CIRCLE SQUARE PLOTS 2, 3 + 4
(FORMERLY KNOWN AS BBC SITE)
OXFORD ROAD, MANCHESTER

Non-Material Amendments
April 2020

2.1 Planning Approved Drawing - East Elevation

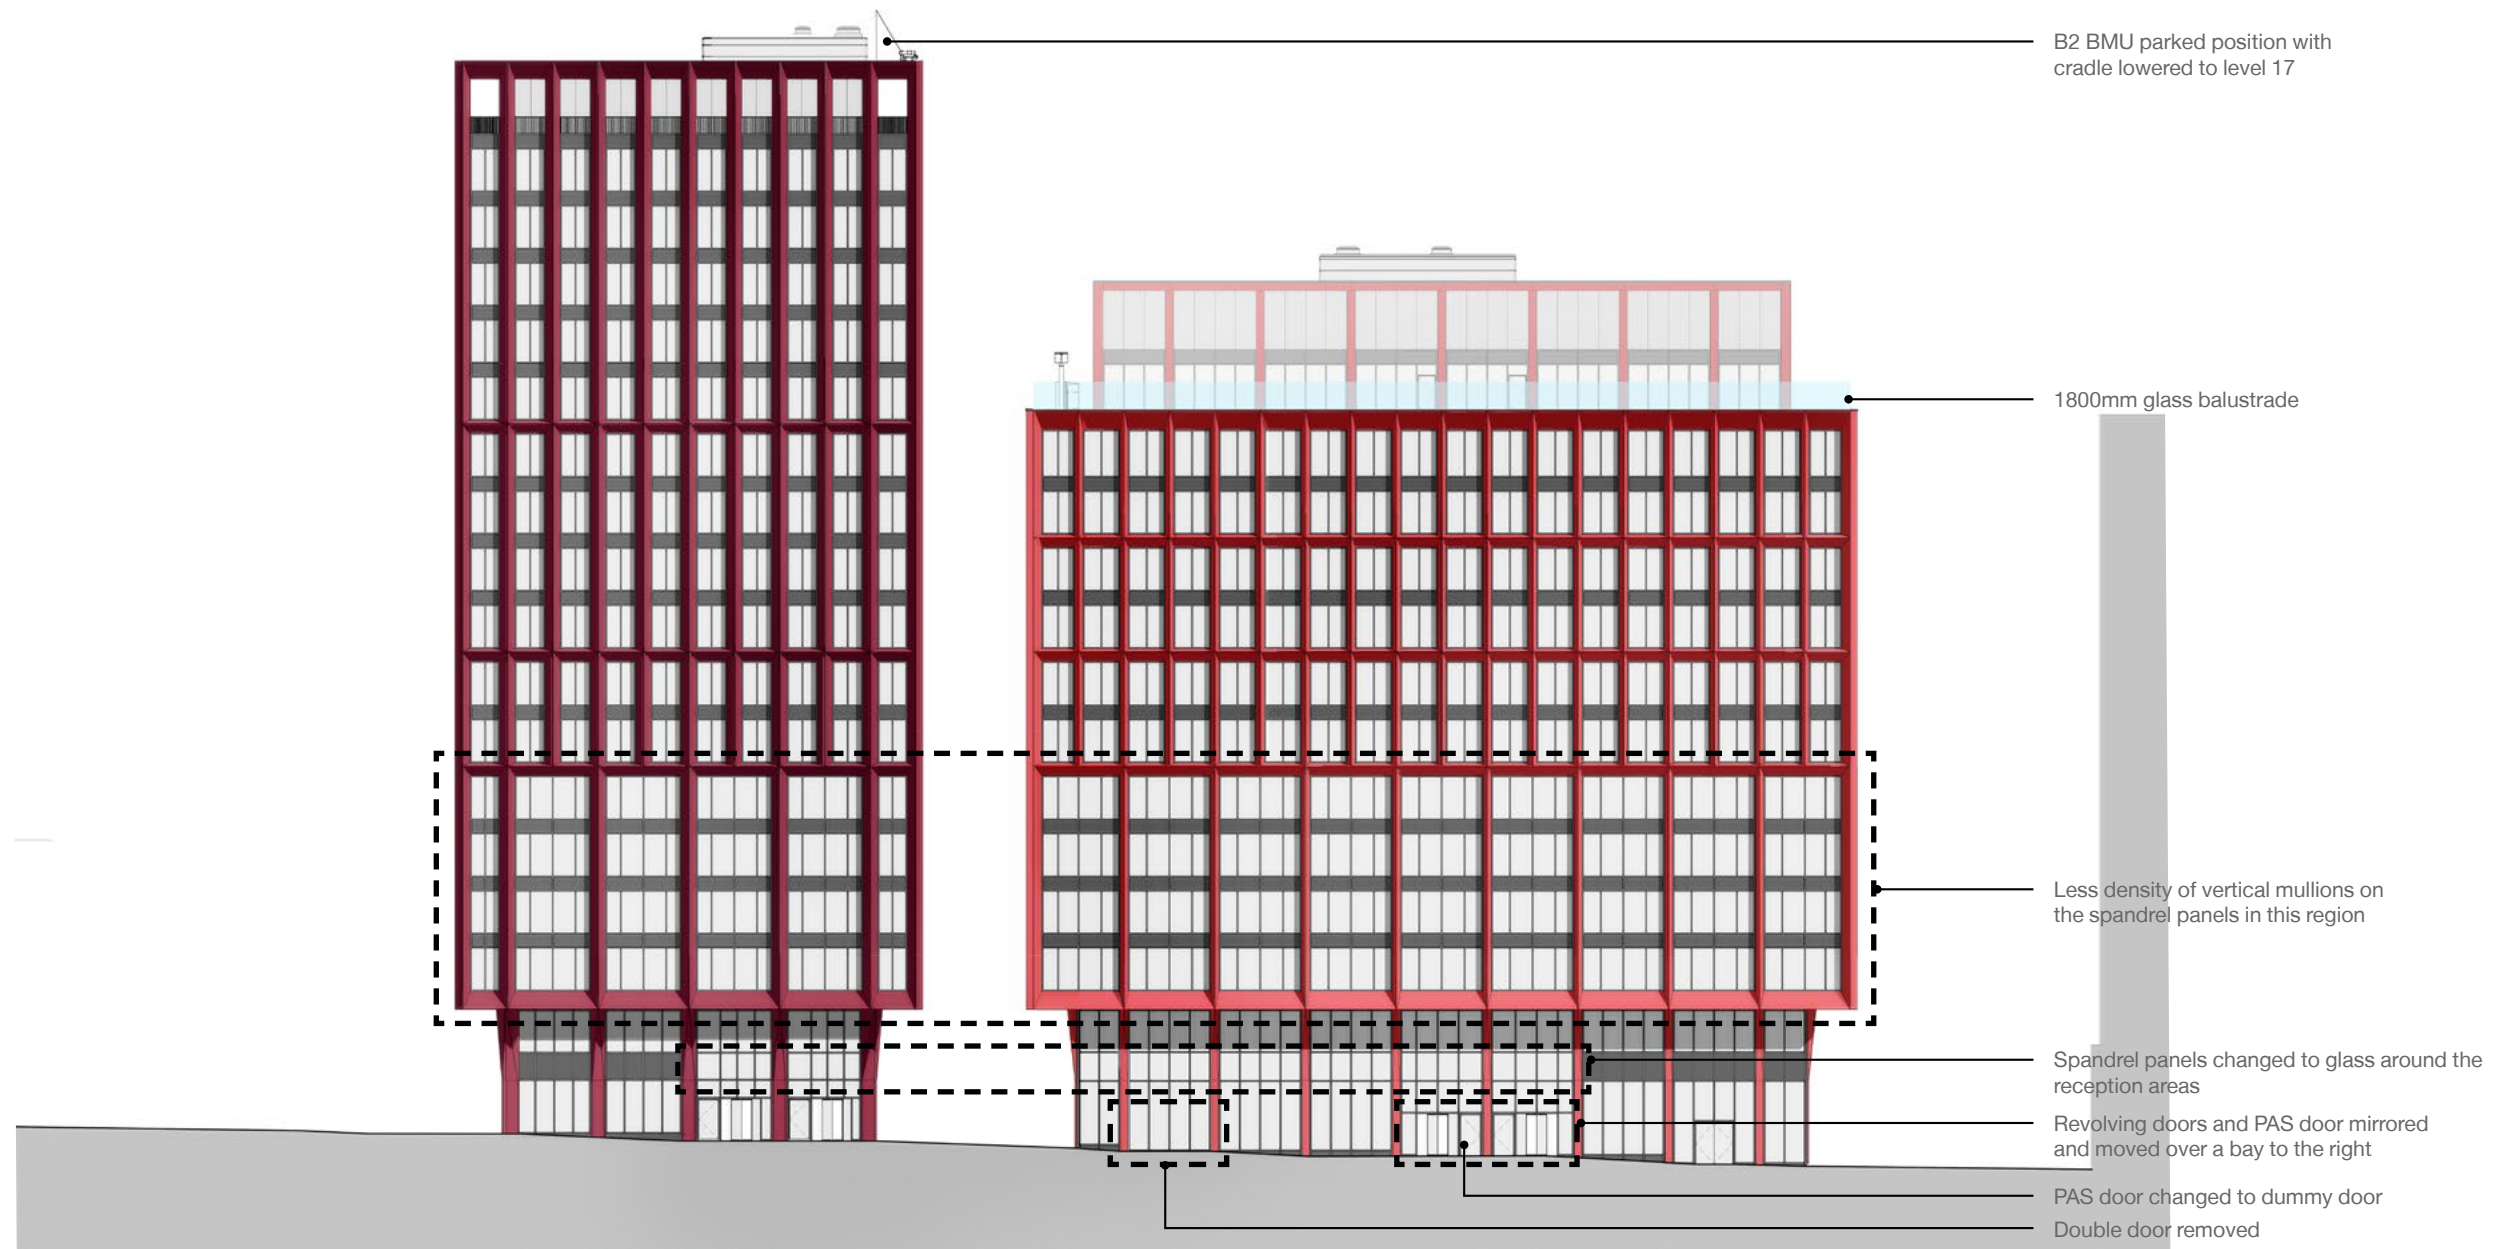
Intermediate vertical mullions removed from the spandrel panels of Levels 2-5 to create more variation across the facade moving up the building.

2.1 Planning Approved Drawing - South Elevation

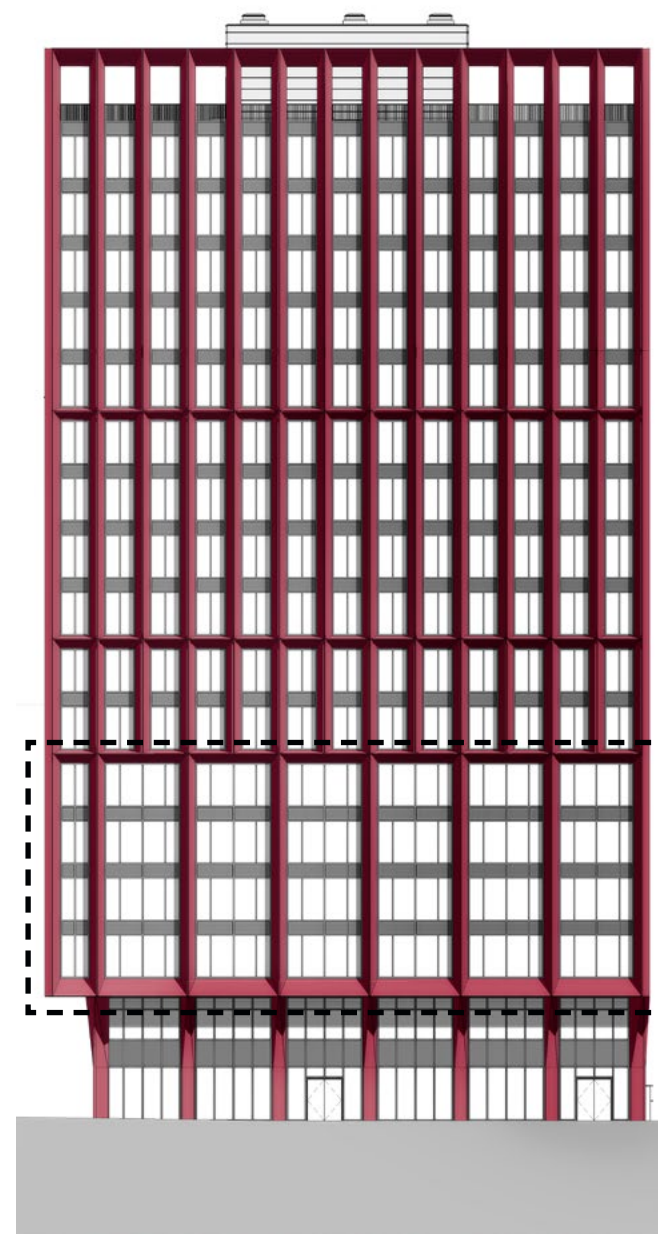
Less density of vertical mullions on the spandrel panels in this region

2.1 Planning Approved Drawing and Stage 5 (Current) Drawing - North Elevation

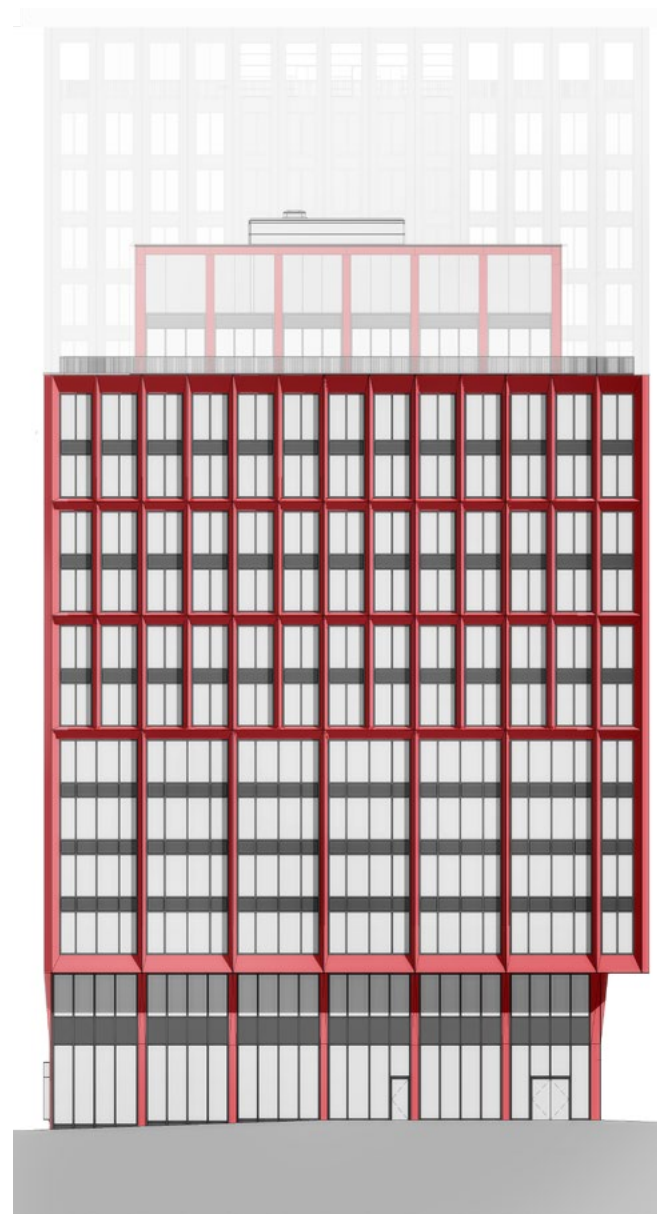
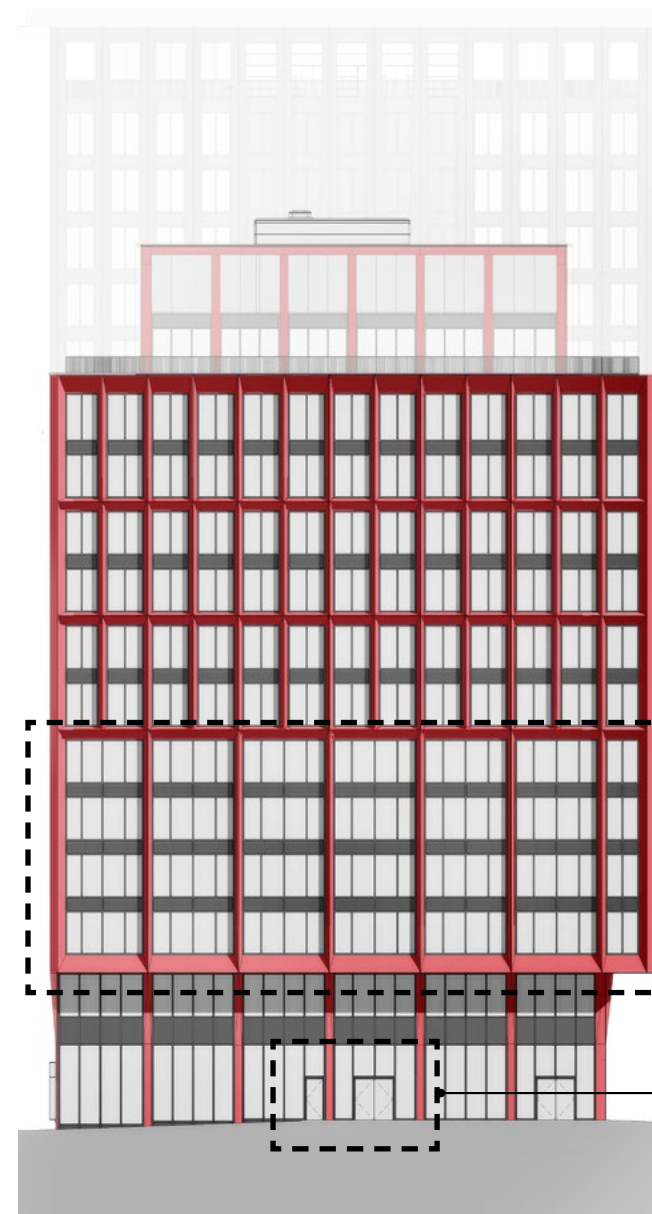
Less density of vertical mullions on the spandrel panels in this region

New door locations
